June 24, 2020, Council Meeting.

Written comments received by city staff
for HI-04-20,
as of 5:00 p.m., Tuesday, June 23, 2020.

RE: HI-04-20 Historic Review of New Construction

HI-04-20 Testimony

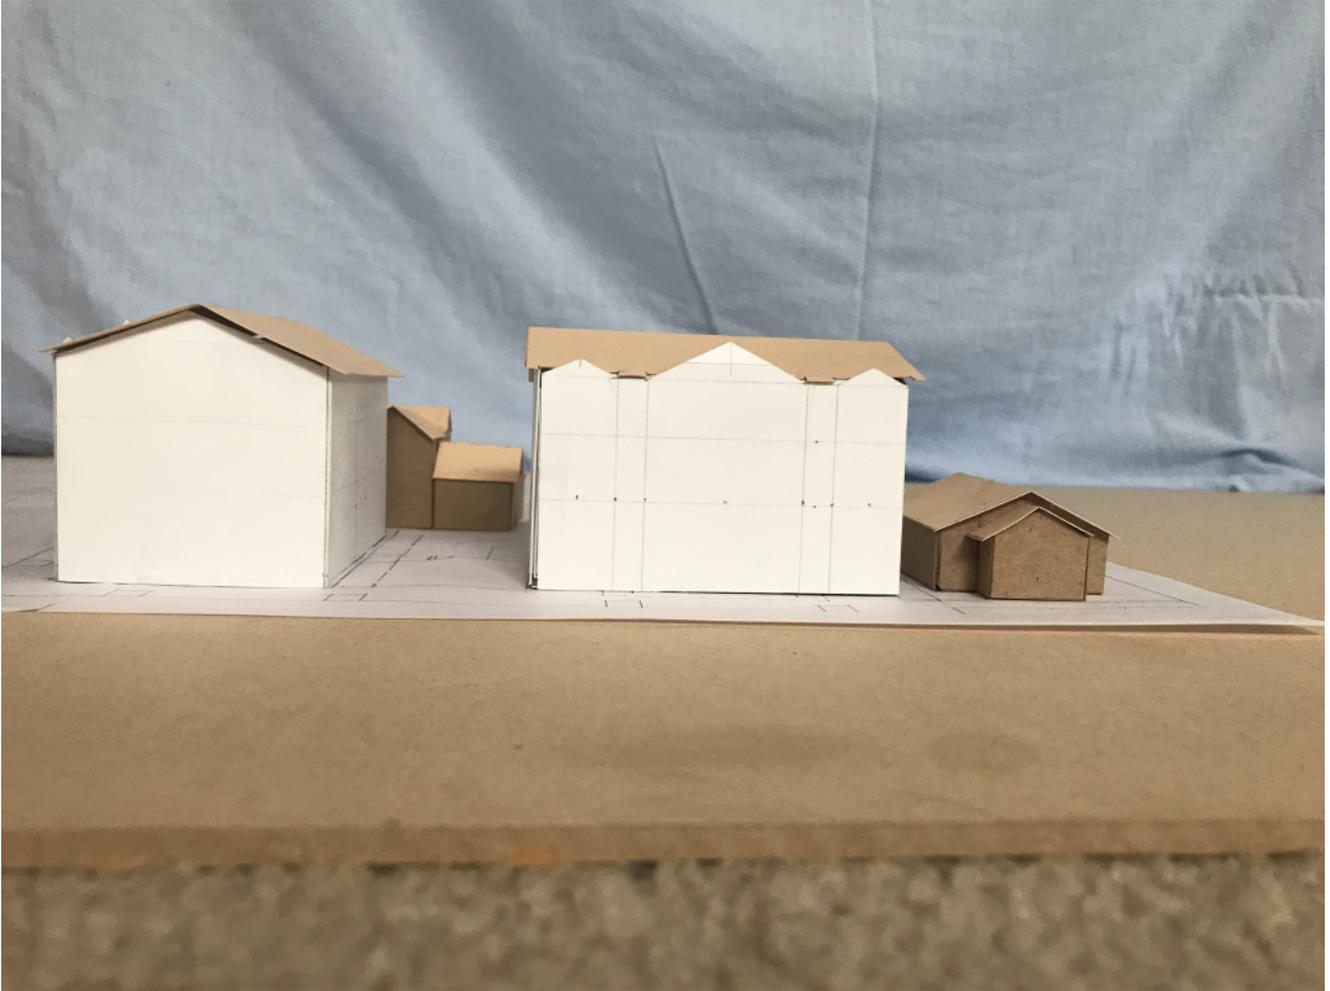
In order to get a sense of the total size of these buildings, we constructed a 1/16 scale model, using a combination of the submitted drawings, the City's InfoHub map, Google Maps and field measurements. It shows the mass of the proposed buildings to the mass of the abutting neighbor properties directly to the north and east. At 40'10" tall, 57'10" wide, and 6,732 square feet, the proposed structures are immensely larger than surrounding buildings. They are so out of scale that shaving a few feet here or there will not help, there is no

hiding their domination of their corner of the block. This is the textbook definition of “overwhelming.” See Figures 6-10. Look at the scale models and then look at the “THIS/NOT THIS” drawings at the bottom of page 4 & 5 of the design guidelines (pages 30 & 31 of agenda packet). How can the City of Albany justify that the new construction proposed falls into the “THIS” category?

Figure 11. Square Footage Comparison of Proposal to Neighboring Properties.

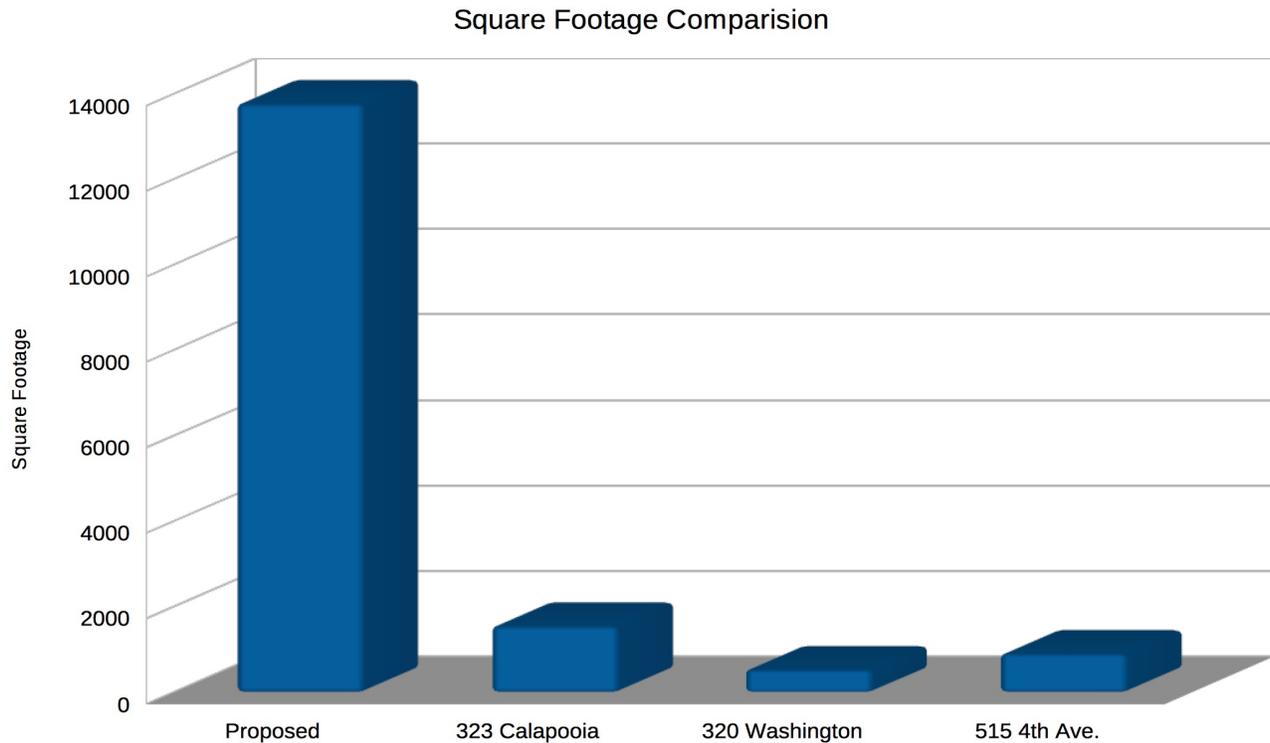
From Table 2 of the staff report, it is shown that proposed building 1 and 2 are over twice as wide as any of the neighboring buildings.

Each main building exhibits from 4 to 13 times the square footage of any of the abutting properties. The four proposed buildings have a combined size of 13,774 square feet! This results in 9 to 26 times the square footage when compared to abutting properties. This massively incompatible discrepancy is visualized in Figure 11.

The proposed structures are 10 to 20 feet taller than abutting properties. The proposed structures are twice as wide. And combined they are 9 to 26 times more massive. No amount of articulation or finishes, no magic can of paint, can hide the fundamental and massive incompatibility of these structures. How would finishes or paint even matter at night? Too large is too large. They are not of similar size and scale of surrounding buildings and clearly violate ADC criteria 7.270 (1)(b).
